ADDENDUM NO.: ONE

DATE: September 9 2015

PROJECT TITLE: **Spent Fuel Research Labs Upfit**

University of South Carolina
State Project No. H27-Z209 - B
WTS Project No. 1433

Plan view
Scale: 3/32" = 1'-0"

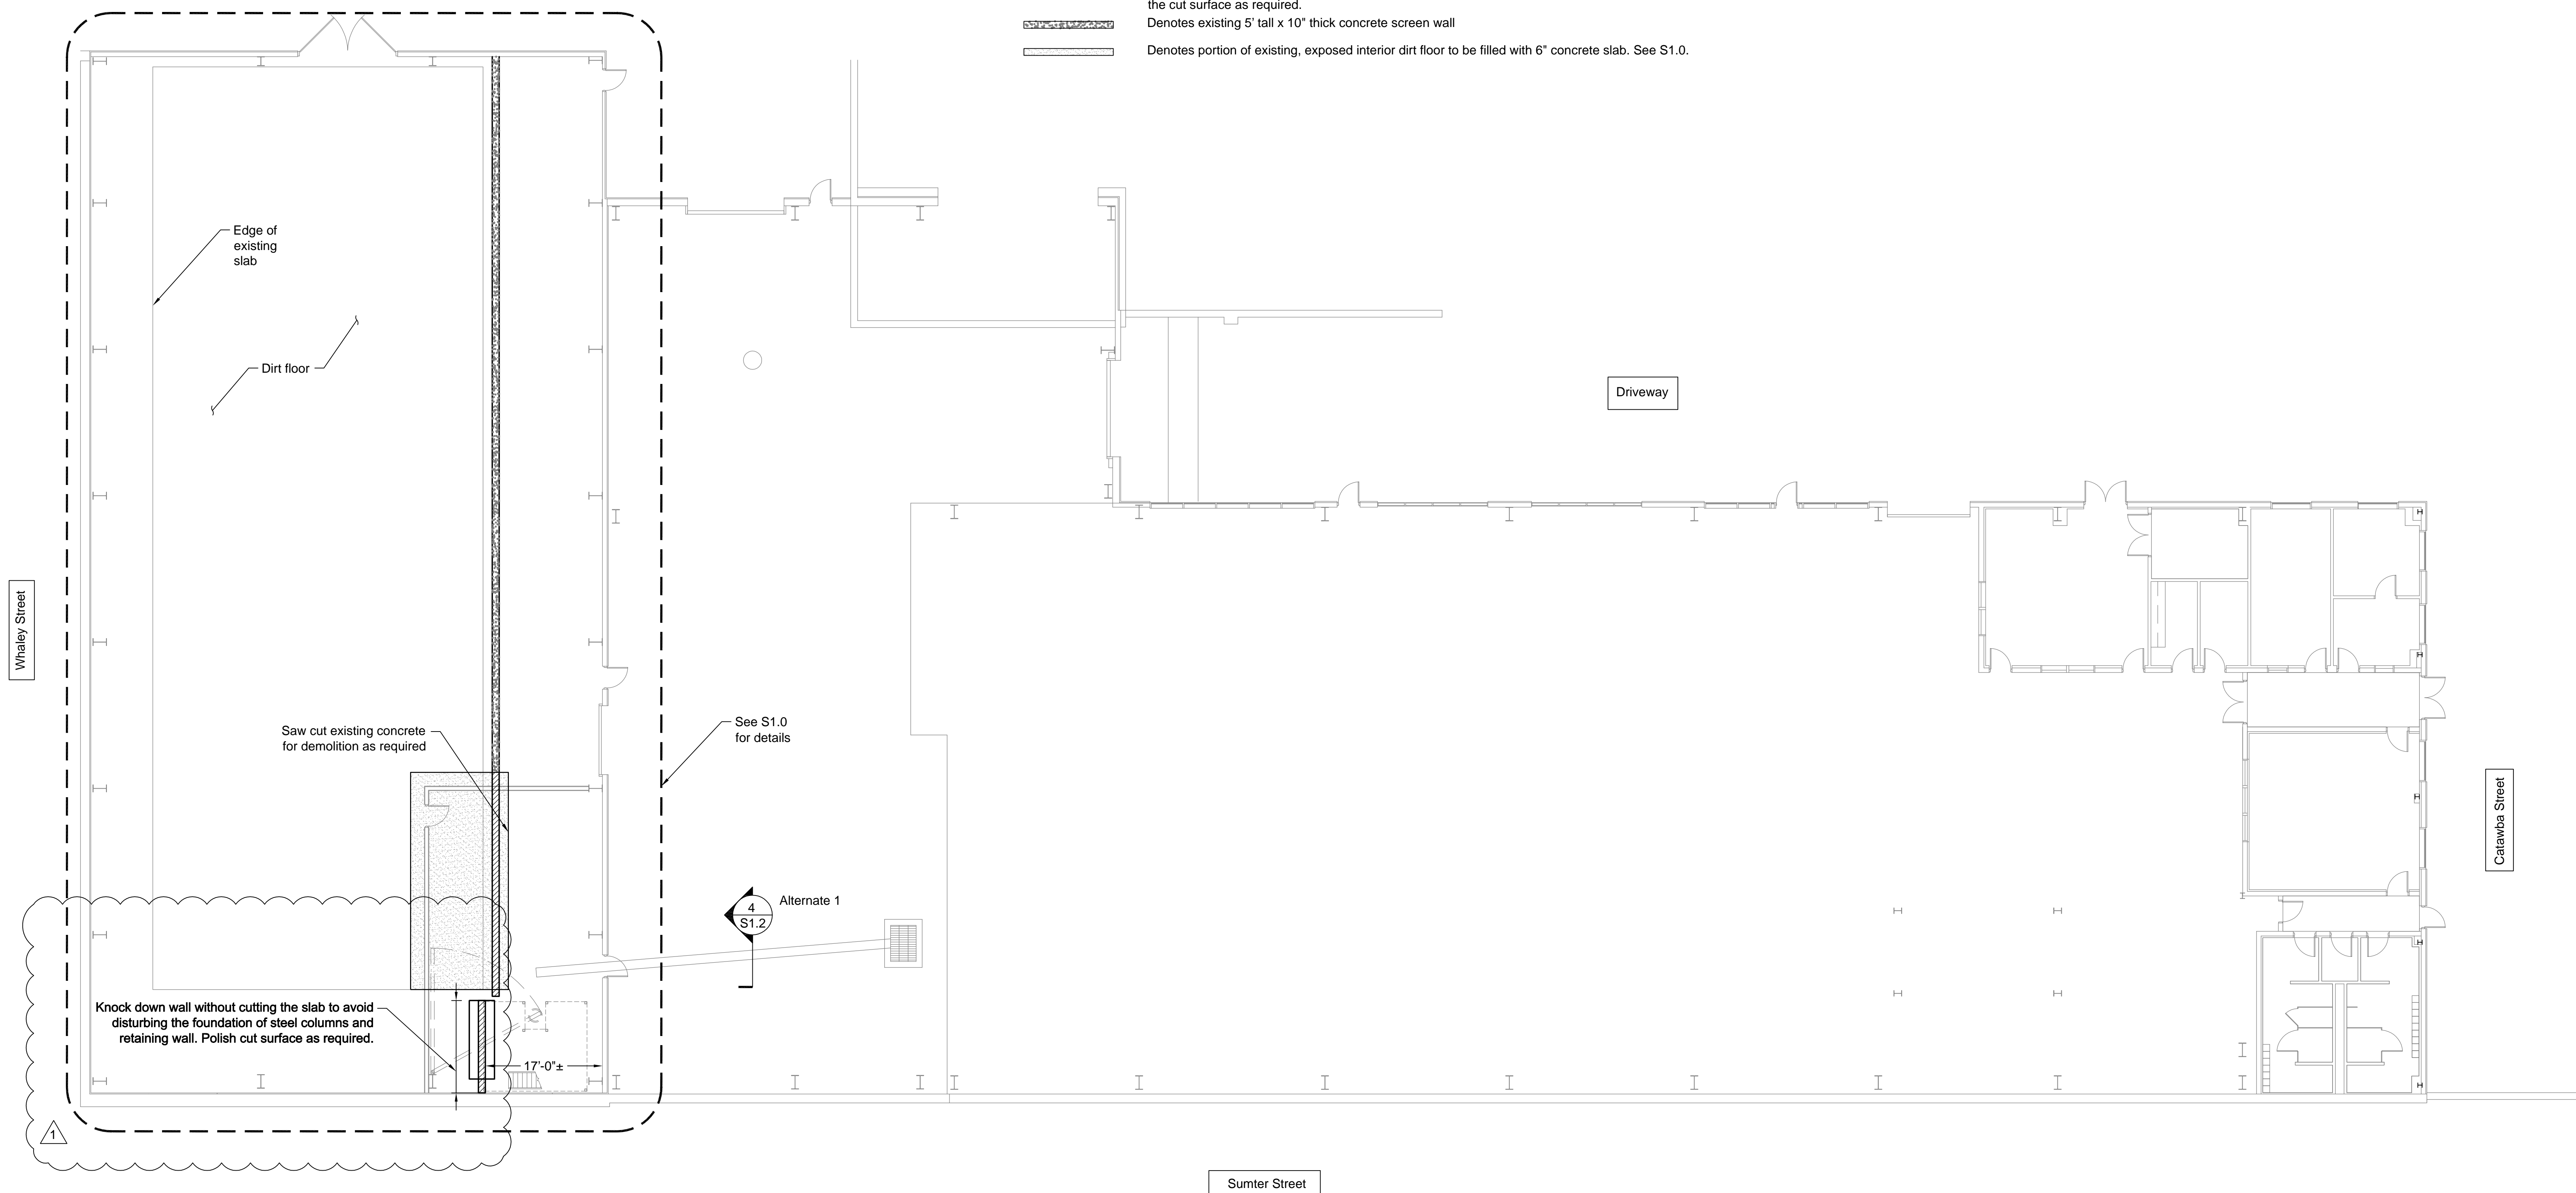
2. Sheet S0.0 Please explain the wording (knock down 2’ of wall length)
See revised drawings S0.0, S1.0, and S1.2
3. Sheet S1.2 Detail 3 Shows 19 ga 8” Z girts spaced a 2’ o/c. The corrugated wall panels are typically 3’ wide. How are the wall panels to attach? And at what fastener spacing?
Typical wall panels will be attached to Z girts spaced at 2’ o/c. A typical 3 foot wall panel can overlap the adjacent panel or be trimmed to work with the 2’ o/c support. Spacing for fasteners should follow the manufacturer’s recommendation. There is no wind load on the metal building wall panels.

-  Denotes existing 5' tall x 10" thick concrete screen wall to be demolished. The demolition can be achieved by saw cutting existing concrete slab/footing, or knocking down the wall while preserving slab/footing below and polishing the cut surface as required.
-  Denotes existing 5' tall x 10" thick concrete screen wall
-  Denotes portion of existing, exposed interior dirt floor to be filled with 6" concrete slab. See S1.0.
